# dsPIC33EPXXXGP50X, dsPIC33EPXXXMC20X/50X and PIC24EPXXXGP/MC20X

## dsPIC33EPXXXGP50X, dsPIC33EPXXXMC20X/50X and PIC24EPXXXGP/MC20X Family Silicon Errata and Data Sheet Clarification

The dsPIC33EPXXXGP50X, dsPIC33EPXXXMC20X/50X and PIC24EPXXXGP/MC20X family devices that you have received conform functionally to the current Device Data Sheet (DS70000657J), except for the anomalies described in this document.

**FIGURE 1: TIMING DIAGRAMS FOR CENTER-ALIGNED AND EDGE-ALIGNED MODES**

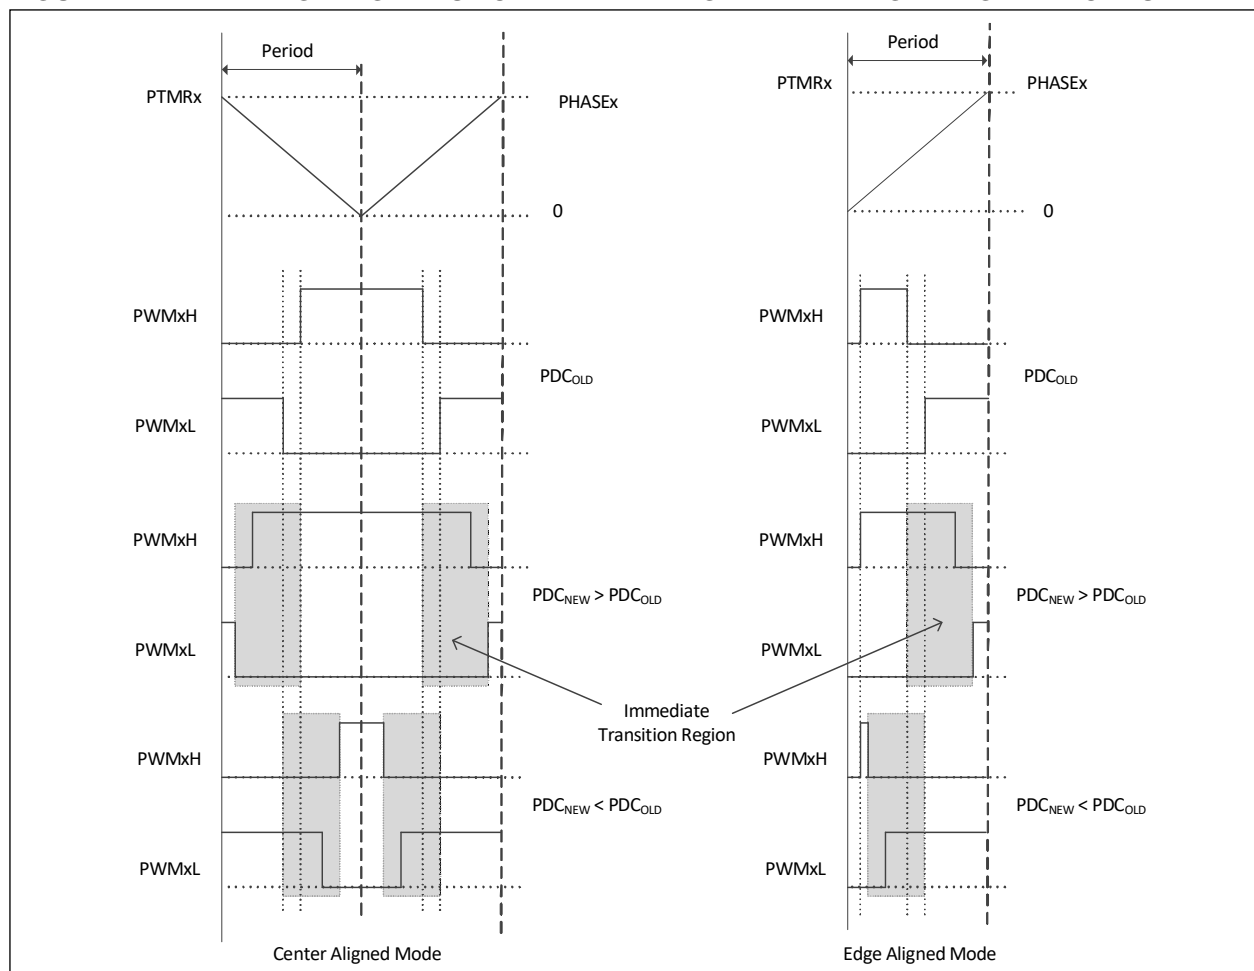
time base, will determine if the PWMxH and PWMxL outputs make an immediate transition. PWMxH and PWMxL outputs make an immediate transition if the Duty Cycle register is written with a new value, PDC<sub>NEW</sub>, at a point of time when the PWM time base is counting a value that is in between PDC<sub>NEW</sub> and PDC<sub>OLD</sub>. Additionally, writing to the Duty Cycle register, close to the instant of time where dead time is being applied, may result in a reduced dead time effective on the PWMxH and PWMxL transition edges.

In Figure 1, if the duty cycle write occurred in the shaded box, then PWMxH and PWMxL will make an immediate transition without dead time.

None.

FIGURE 2: PWM TIMING DIAGRAM

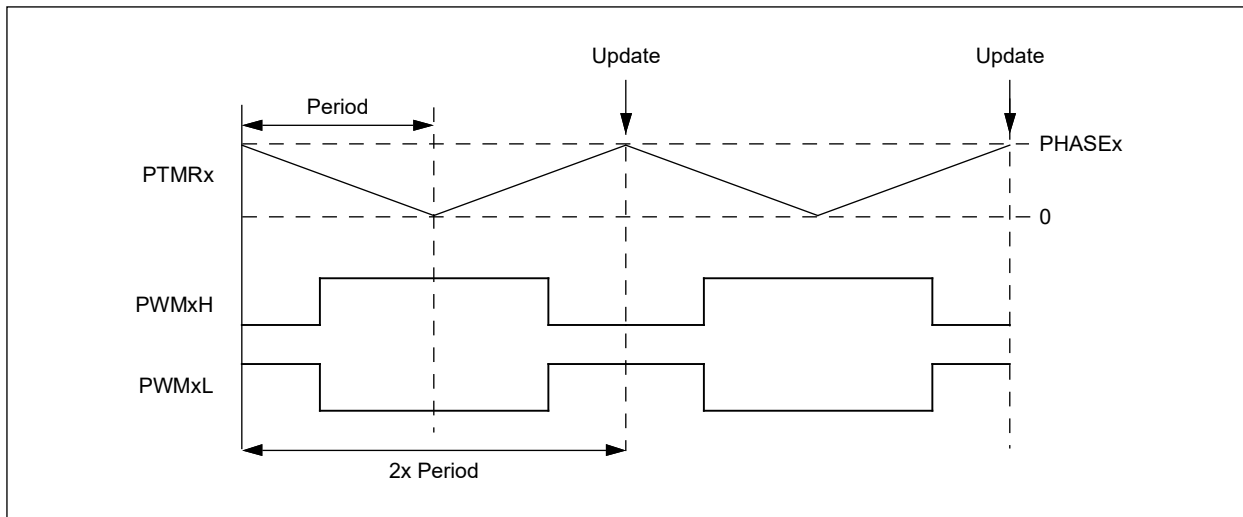
In Center-Aligned mode, updates to active MDC/PDC<sub>x</sub>/ALTDTR<sub>x</sub>/PHASE<sub>x</sub> registers occur only once every two PWM periods; that is, when the PWM timer matches the PHASE<sub>x</sub> register. In other words, the double update feature is not available. Figure 2 illustrates this relationship.

**FIGURE 3: CORRECT AND INCORRECT POSITION COUNT CAPTURES**

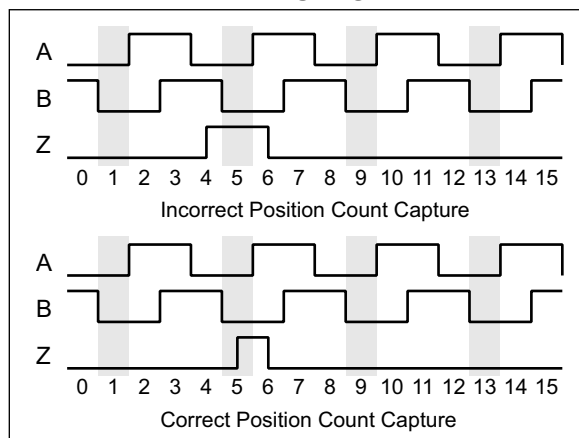
When index count position capture is being used ( $QE1IOC.QCAPEN = 1$ ), the position count may be one more or one less than the correct value, depending on the direction of the count.

This is only observed when the leading edge of the index pulse occurs prior to the leading edge of the index match event. When the index pulse starts after the leading edge of the index match event, the position count is captured correctly.

Figure 3 shows how this occurs. In these cases, Encoder Signals A, B and (index) Z are shown, with the module being configured for index match when A and B are '0'. The effects of a correct and incorrect capture are shown side by side (shaded areas indicate the index match event); the position count is shown along the bottom.

For encoder signals with timing that ensures the index pulse always starts prior to the start of the index match event (i.e., encoders with a non-gated index pulse), measure the direction of the encoder motion. If the encoder is counting up, add one to the captured position count; if the encoder is counting down, subtract one from the captured position count.

For encoder signals where the index pulse leading edge approximately coincides with the start of the index match event (i.e., encoders with a gated index pulse), a small delay can be added to the index pulse, for instance, by using a simple R-C filter.

**FIGURE 4: PWM GENERATOR TIMING DIAGRAM**

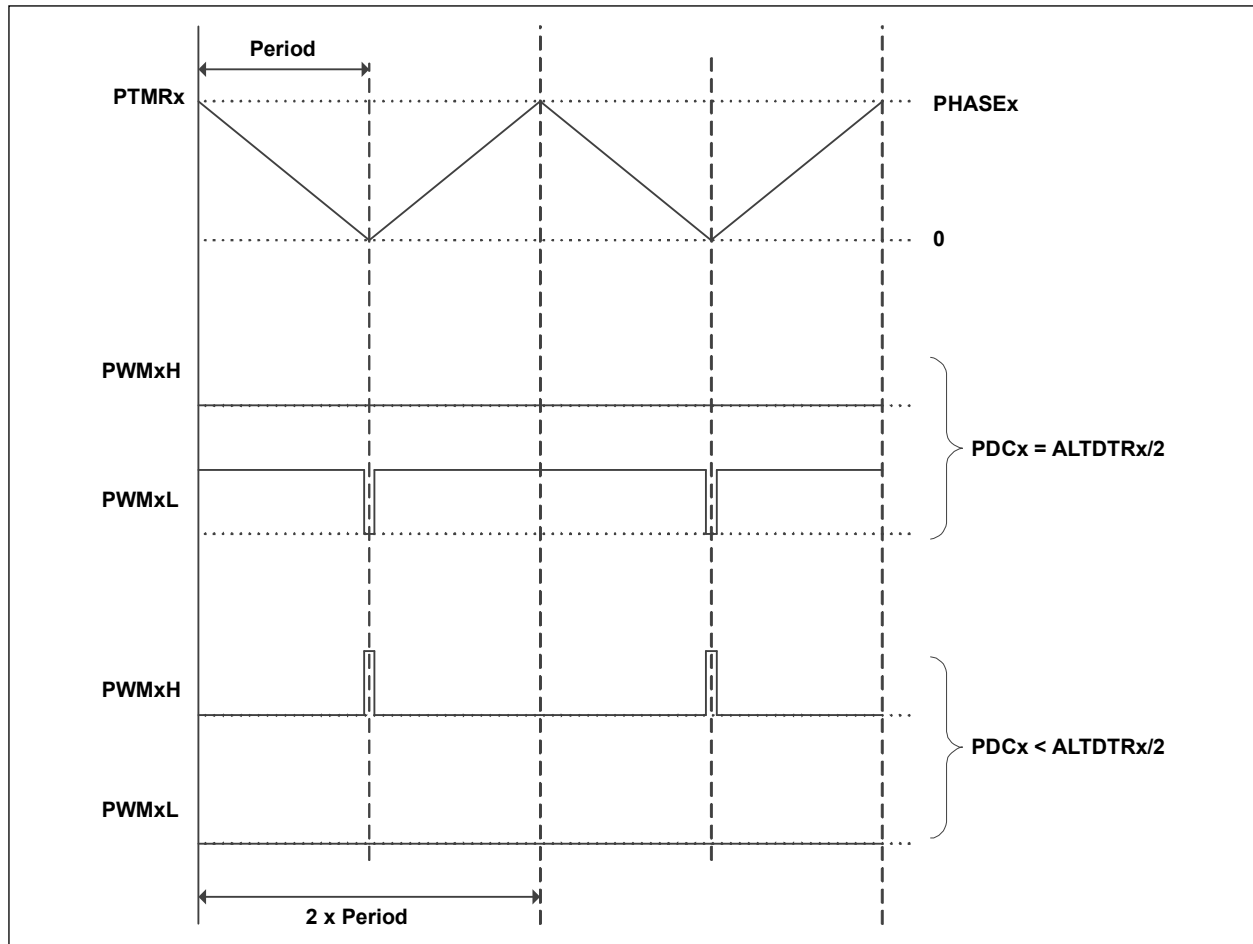
In Center-Aligned Complementary mode with Independent Time Base, if the value in the PDCx register is less than one-half the value in the ALTDTRx register, the PWM generator will force the PWMxL to low, and on the PWMxH, generate pulses of width less than twice the dead time, as shown in Figure 4.

FIGURE 5: ILLUSTRATION OF 1 T<sub>osc</sub> GLITCH WHEN PWM OVERRIDE IS TURNED OFF

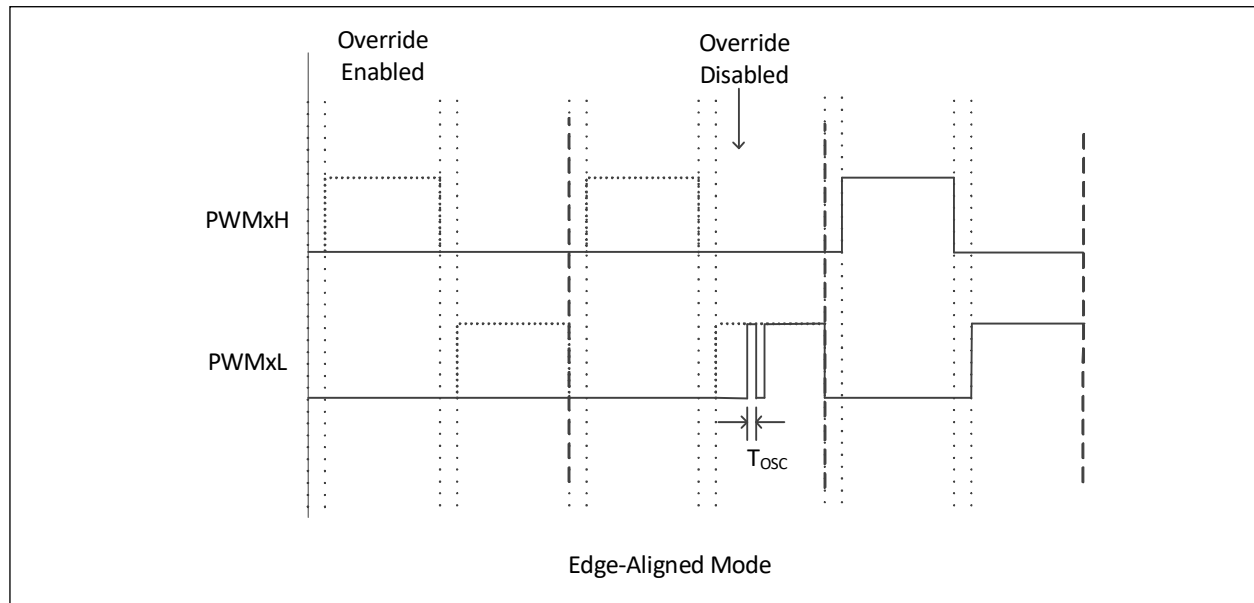
In Complementary mode after the PWMx module is enabled (PTEN = 1), if the PWM override is turned off, a 1 T<sub>osc</sub> glitch will be present on the rising edge of either PWMxH or PWMxL, whichever occurs first, as shown in Figure 5. The glitch will be present on PWMxH/PWMxL every time the override state is changed from enabled to disabled. The width of this glitch is equal to 1 T<sub>osc</sub> when PCLKDIV[2:0] = 000; increasing the PWM input clock prescaler setting will increase the width of the glitch accordingly.

**FIGURE 6:**

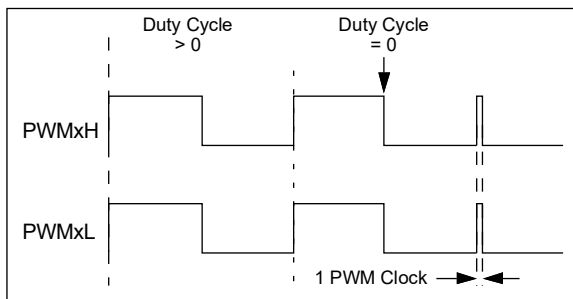
In certain output modes, the PWMx module produces a pulse glitch of one PWM clock in width (Figure 6). This has been observed only when all of the following are true:

- Either Redundant or Push-Pull Output mode is selected (IOCONx[11:10] = 10 or 01);
- Immediate Update is disabled (PWMCONx[0] = 0); and
- The value of the current Duty Cycle register (either the PDCx or MDC register, as determined by PWMCONx[8]) is updated to zero from any non-zero value.

The pulse glitch has been observed to occur at the beginning of the following PWM boundary period.

**FIGURE 7:**

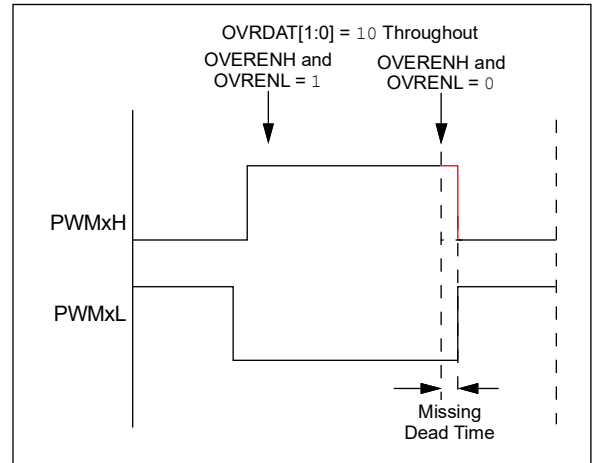
- Output override synchronization is configured to occur on the CPU clock boundary (IOCONx[0] = 0);
- Both PWMxH and PWMxL overrides are enabled prior to the event (OVRENH and OVRENL are both '1'), and
- Both overrides are disabled (OVRENH and OVRENL are both '0') at the instant the dead time should be asserted (Figure 7).

This has been observed in both Center-Aligned and Edge-Aligned modes.

**FIGURE 8:**

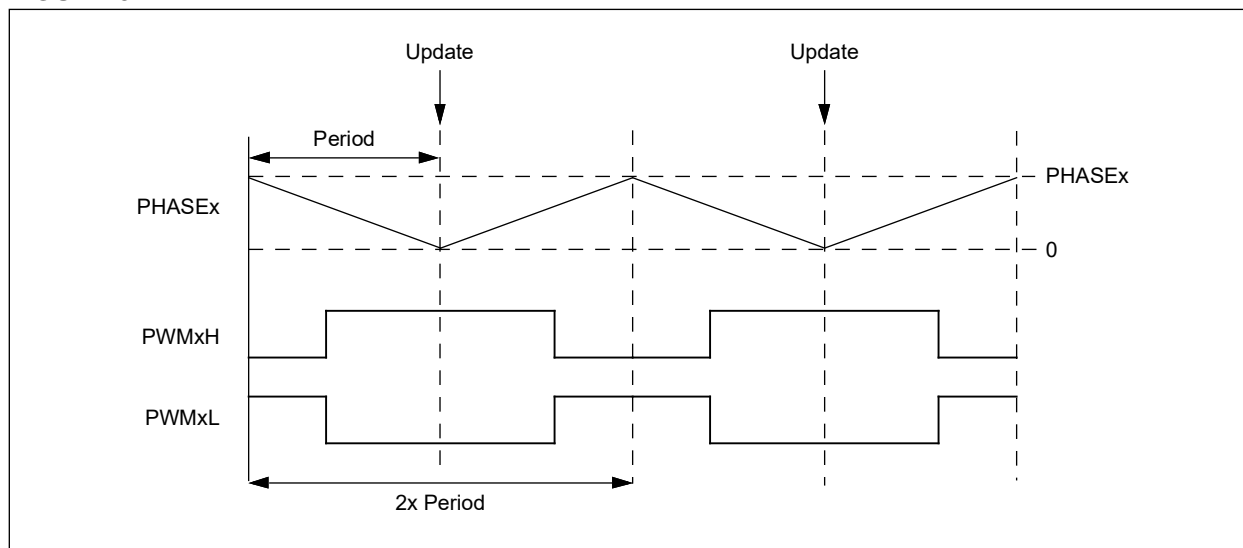
In Center-Aligned Complementary mode with Independent Time Base, updates to the PHASEx register take effect in the middle of a center-aligned PWM cycle, as shown in Figure 8. This occurs only when the Immediate Update feature is disabled (IUE = 0). If Immediate Update is enabled (IUE = 1), the PHASEx register updates will take effect immediately.

**FIGURE 9: SIMPLIFIED BEHAVIOR**

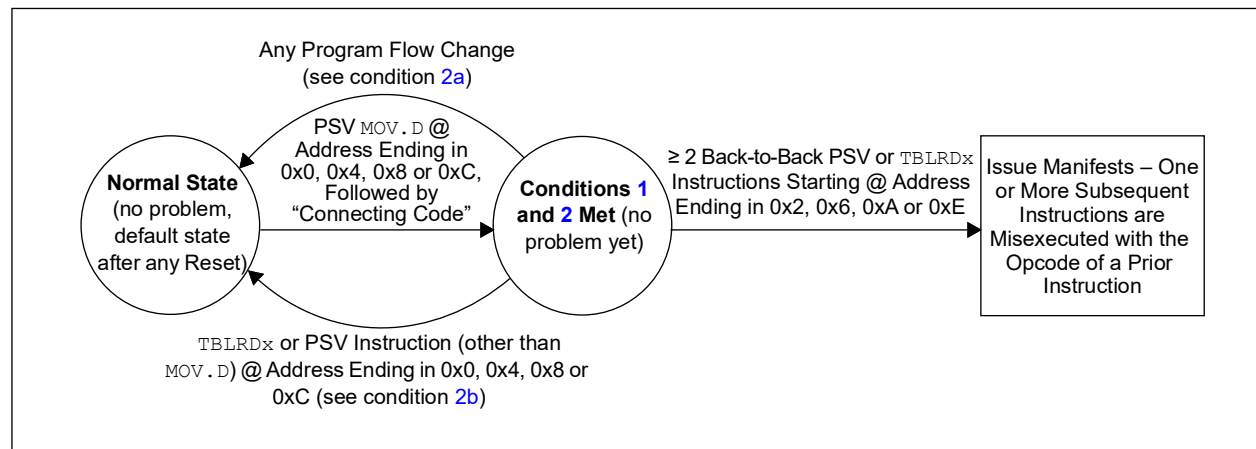
| 3. | ≥ 2 back-to-back PSV or <code>TBLRDx</code> instructions are executed (following the code of condition 2), where the first of the back-to-back instructions is located at an address ending in 0x2, 0x6, 0xA or 0xE.  |

[Figure 9](#) provides an example of the effective behavior.

1. All instances of PSV `MOV.D` can be replaced with two PSV `MOV` instructions instead. Non-PSV `MOV.D` instructions acting on RAM/SFRs do not need to be modified; or
2. If not already present, a program flow change instruction (such as `BRA $+2`) can be inserted above back-to-back data Flash read sequences; or
3. Back-to-back data Flash read instruction sequences can be broken up by inserting a non-Flash read instruction (such as a `NOB`) in between the Flash read instructions; or
4. The alignment of the code can be shifted to avoid the required opcode location addresses.

C code built with MPLAB® XC16 Compiler, Version 1.32, or later, implements the work around by default. However, if the application uses Assembly language routines, these should be manually modified to implement the work around. Additionally, if precompiled libraries are used, these should be built with XC16 Version 1.32 or later. For additional information, please visit: [www.microchip.com/erratum\\_psrds\\_psrds](http://www.microchip.com/erratum_psrds_psrds).
